UNITED STATES PATENT AND TRADEMARK OFFICE

Office Action Summary

10/089,041

GRIMM ET AL.

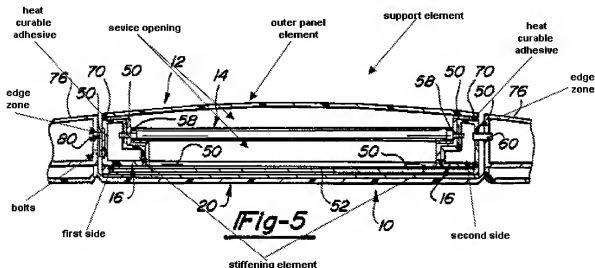
As best understood, claims 13-18, 20-30 and 34-35, 38-41 are further rejected under 35 U.S.C. 102(b) as being anticipated by Ritchie (5,857,732). Ritchie (5,857,732) discloses a vehicle door module comprising a support element (see figure below), an outer panel element (12) to close the service opening along an edge zone, an elongated

metal stiffening element (50), a spacing element (70) in the form of a heat curable adhesive (column 4, lines 34-67) which allows adjustability between the parts (i.e., the outer panel element and the elongated stiffening element) in two dimensions, which are to be fastened, and bolts (80) detachably joined to the stiffening element (50) and support element, an interior panel element (20), and a hinge (80).
